MICHAEL DRISCOLL SCHOOL

OPM Monthly Project Update Report

January 2022

Change Order #8 Summary

DRAWING NAME
EXTERIOR MOCK UP

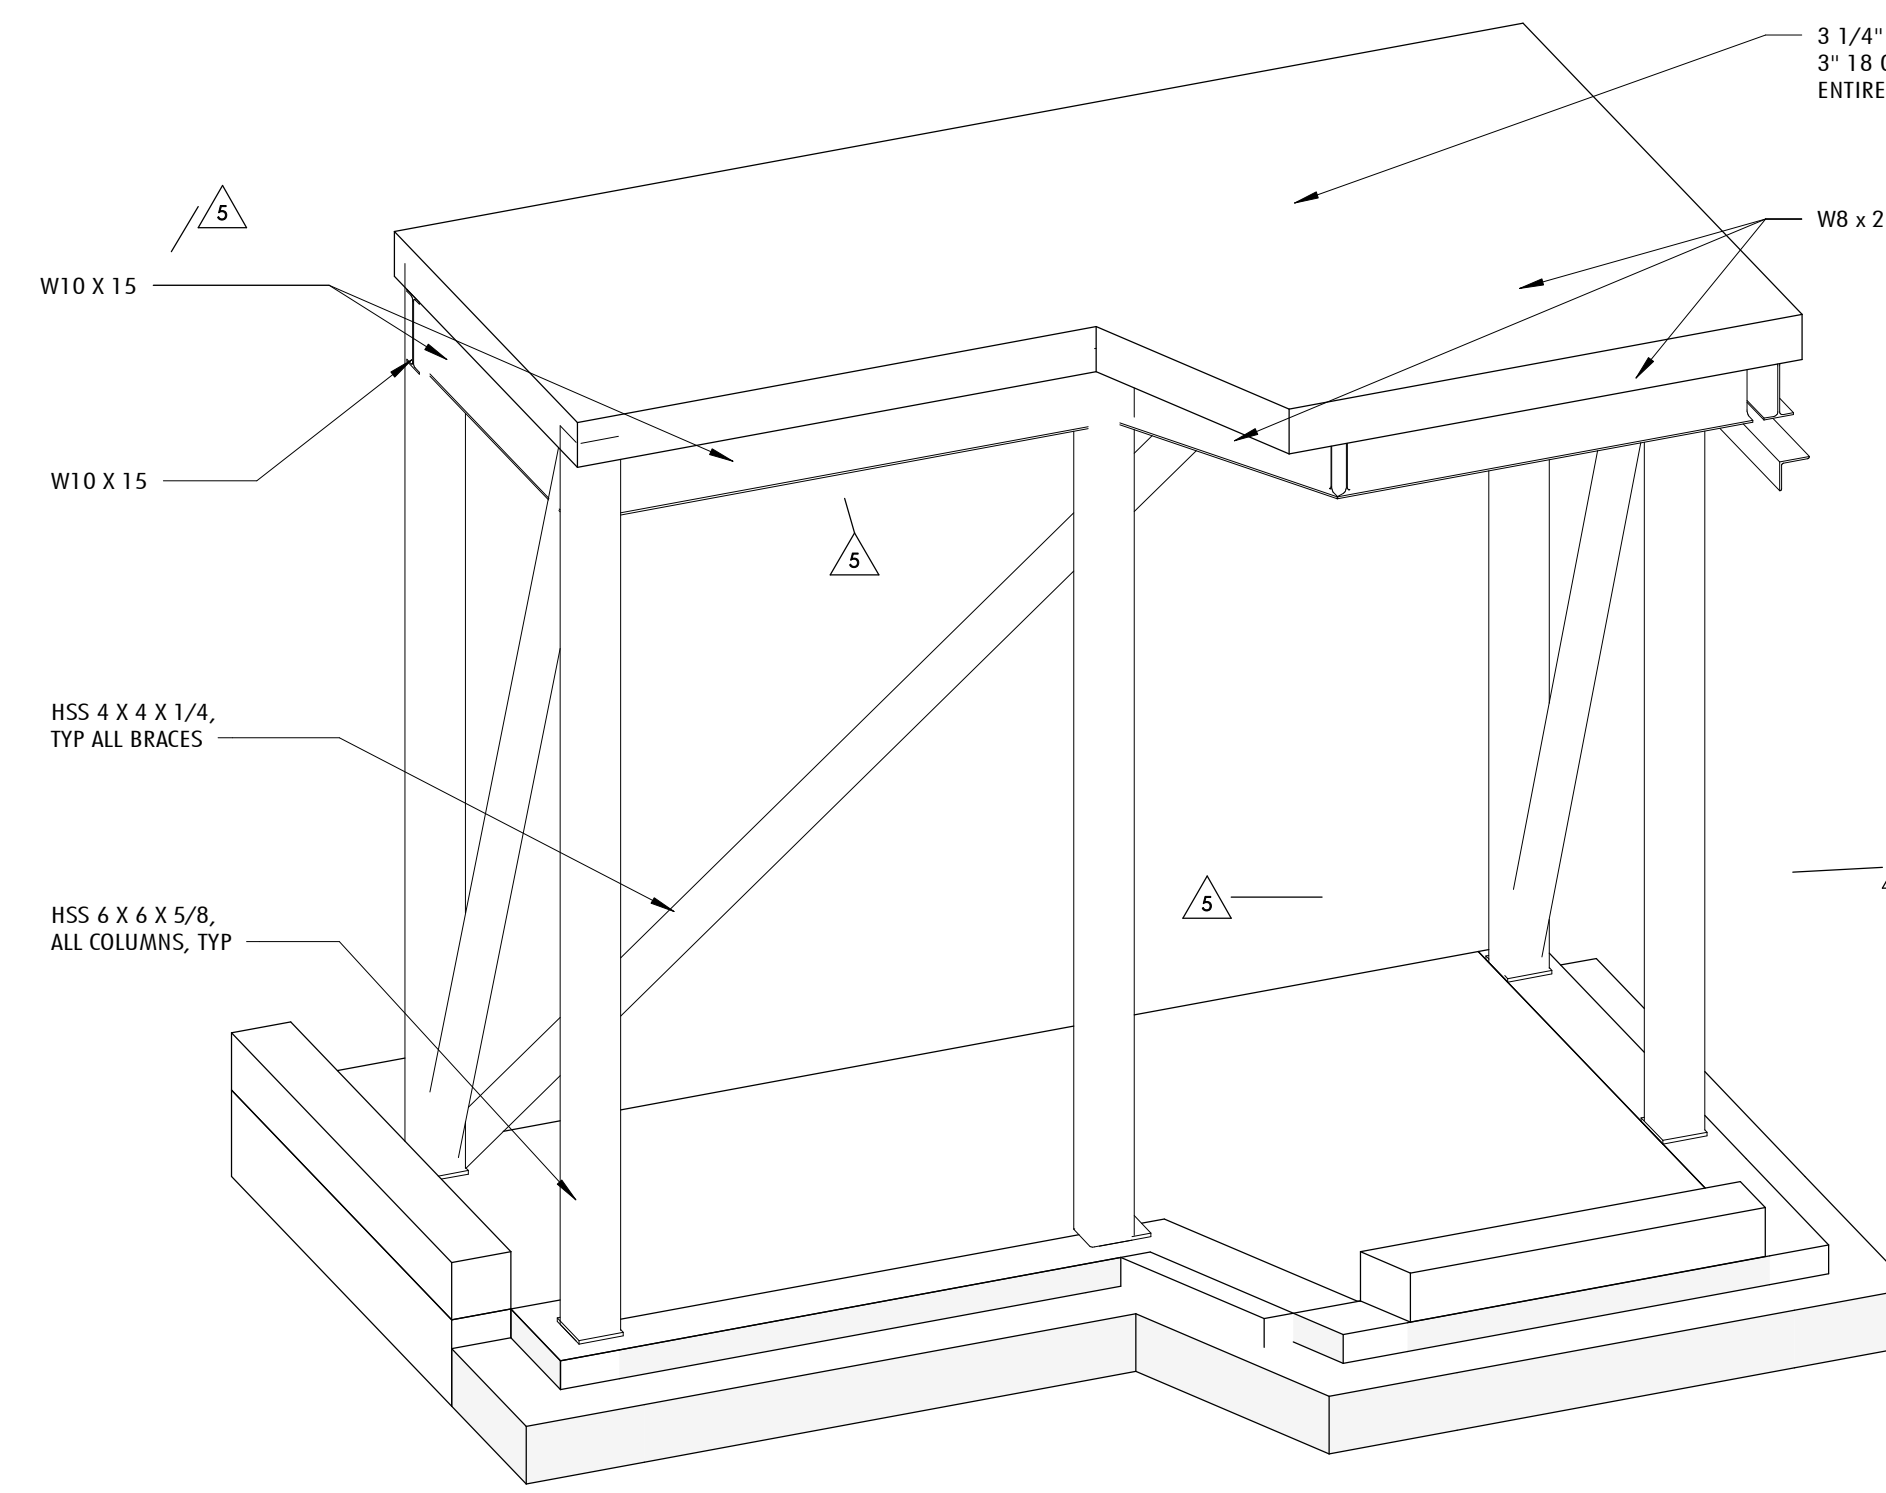
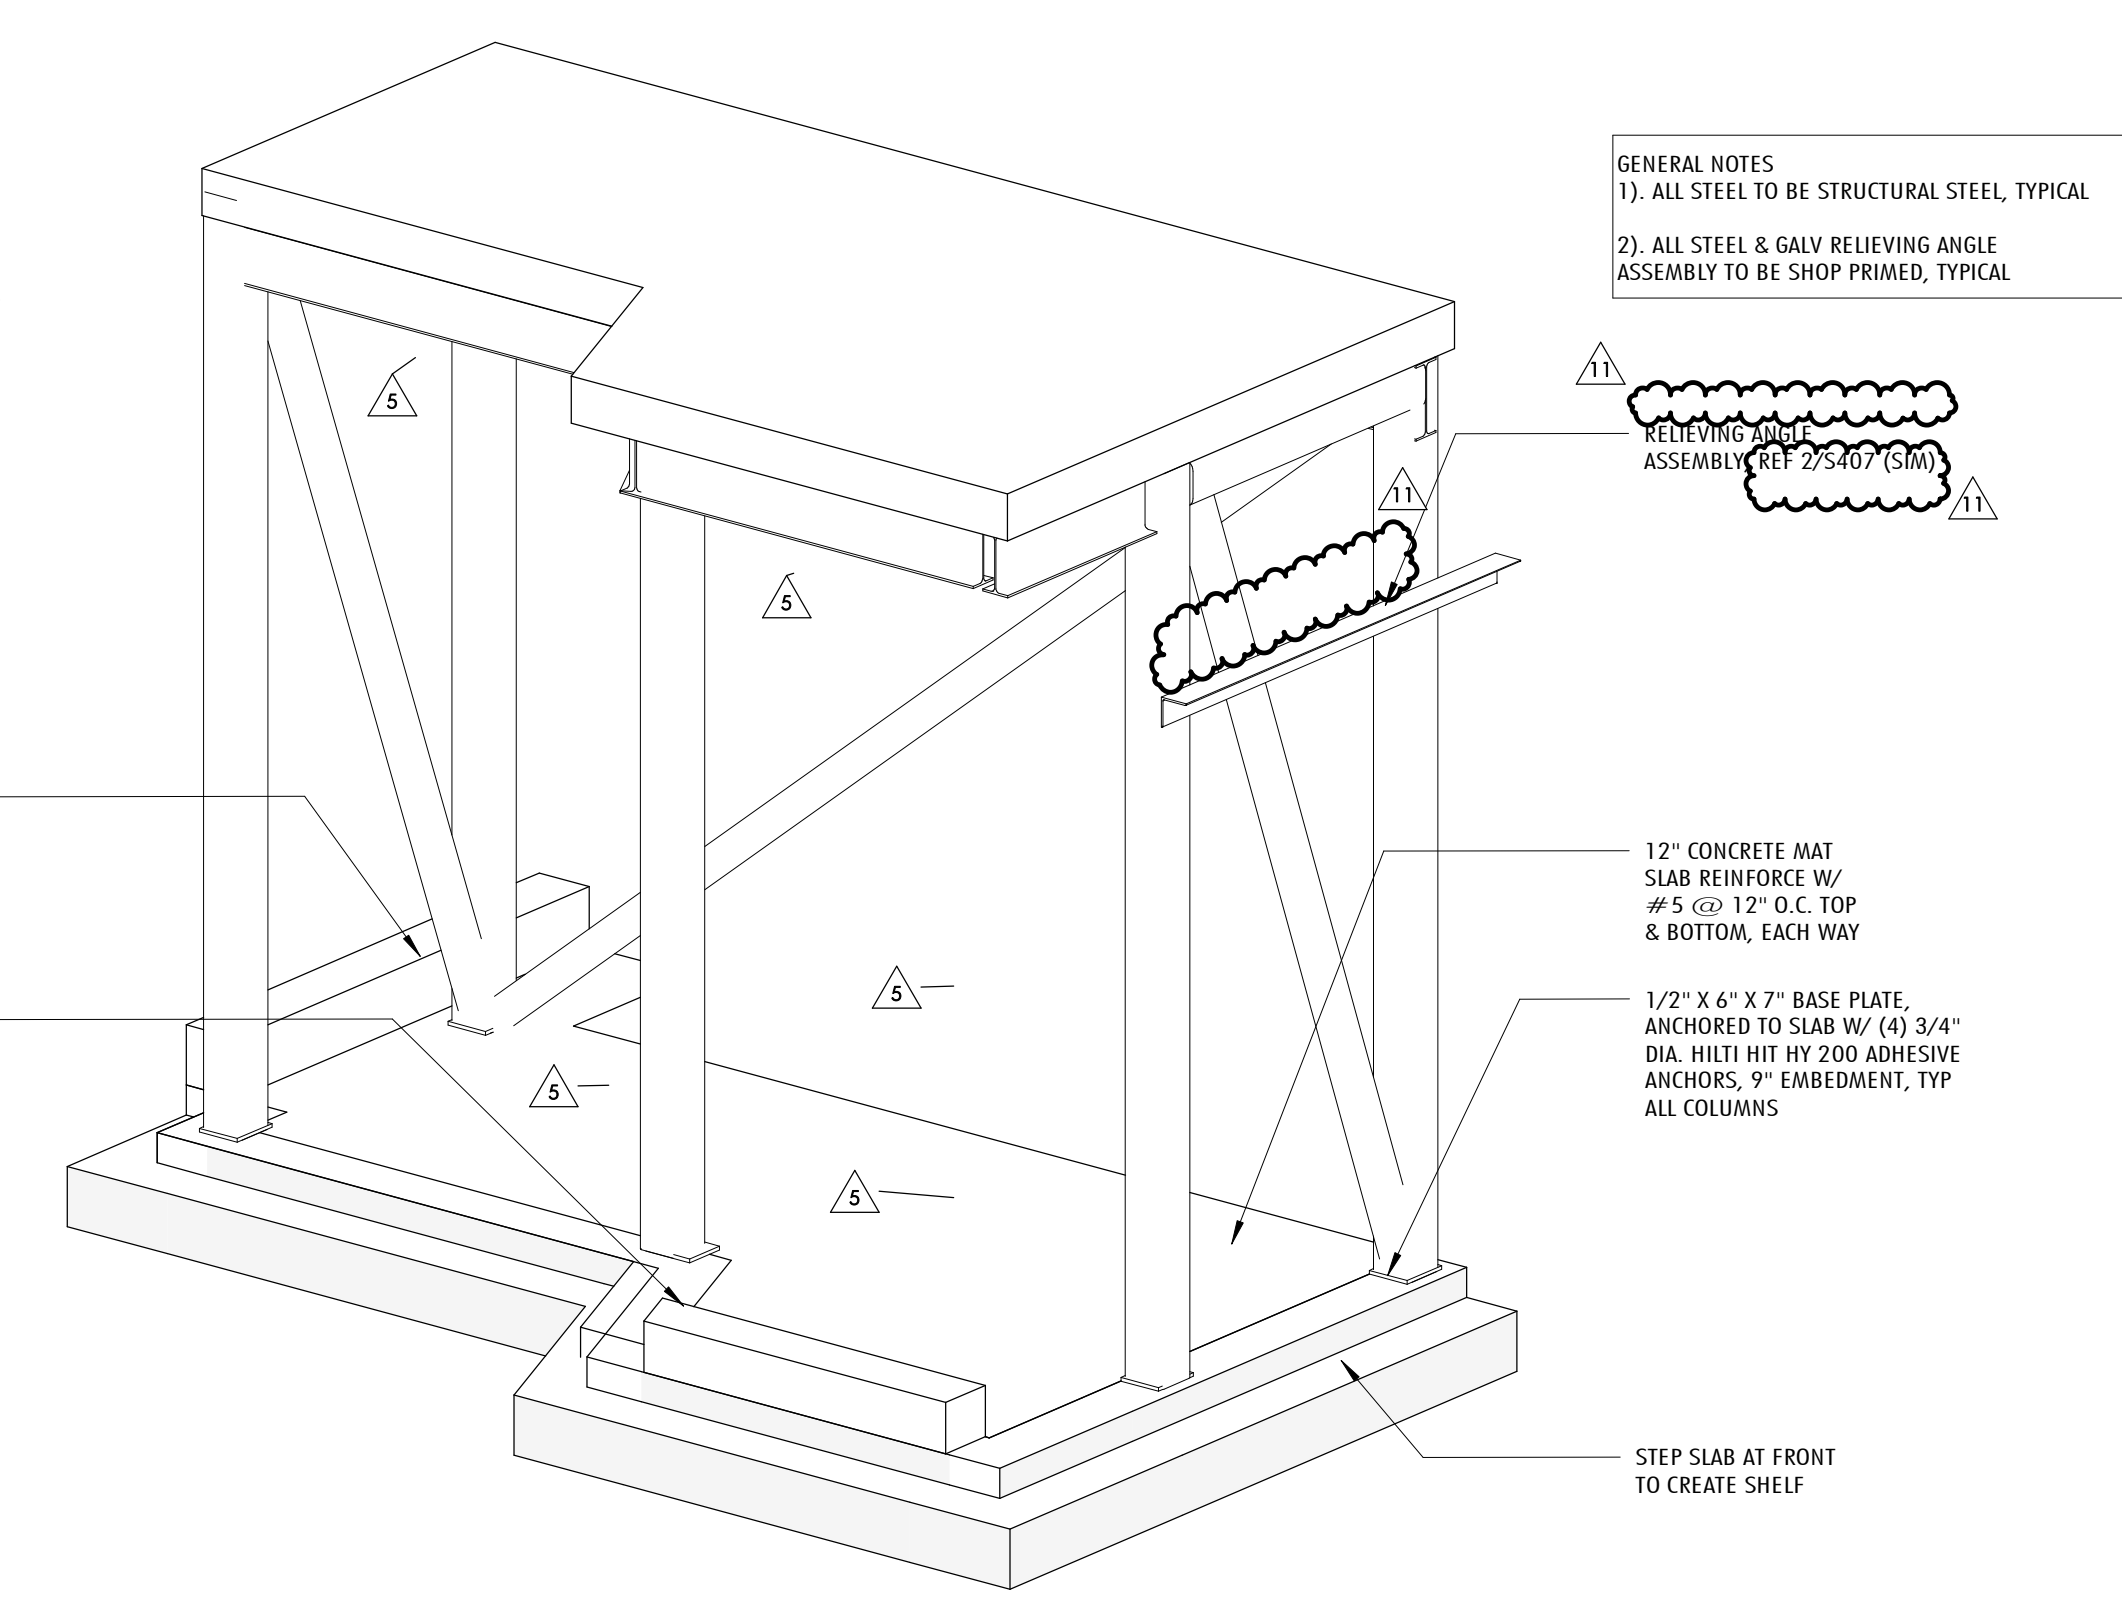
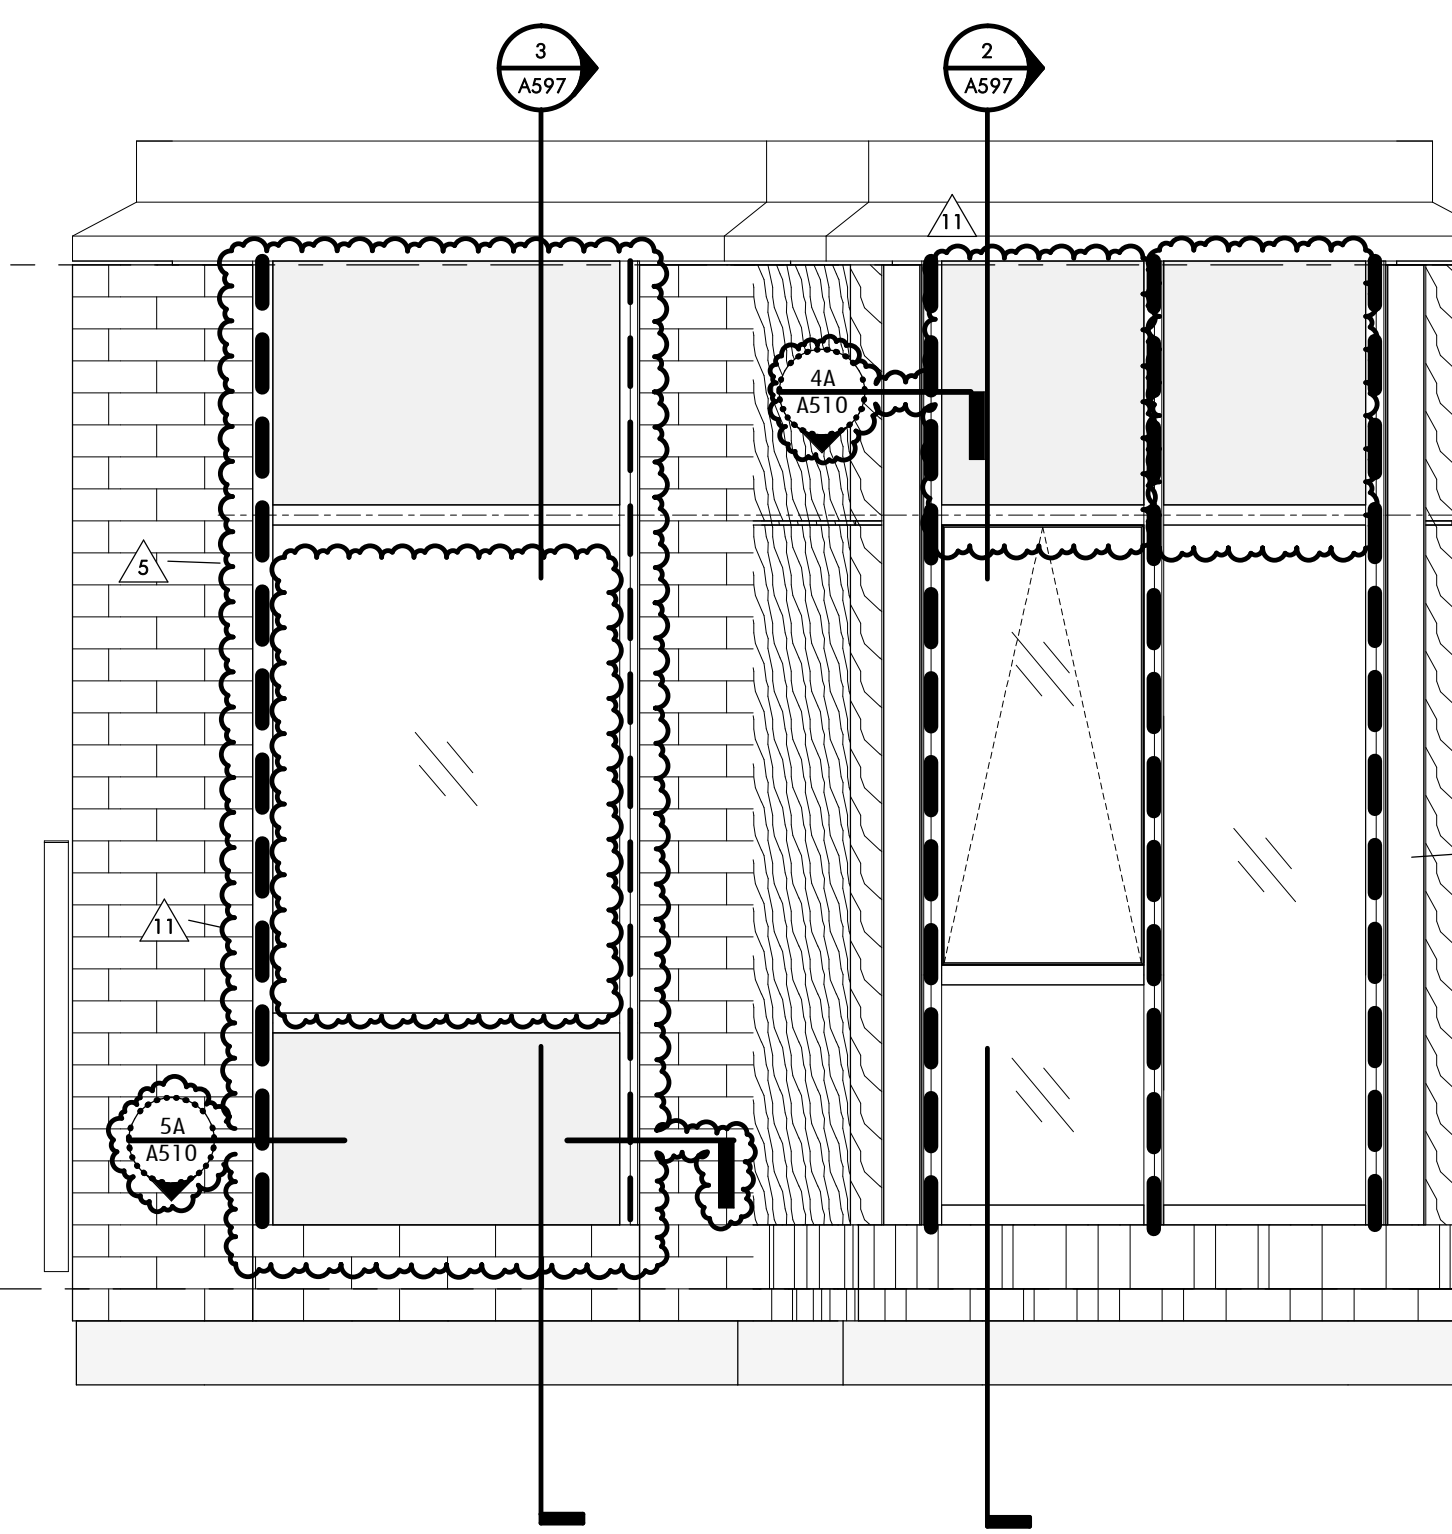
Revisions to Mock Up Drawing A597:

- Phenolic Panels in openings revised to metal panel to reflect contract documents detailing. Callouts added for plan details at metal panel.
- Exterior Materials legend updated to reflect contract documents and ASI 003R.
- Minor adjustments to dimensions and relieving angle joint elevation, as noted in submittal 05 12 00-00 review. WF and HSS steel on details 4 & 10/A597 revised to reflect comments submitted with mock up steel submittal 05 12 00-00.
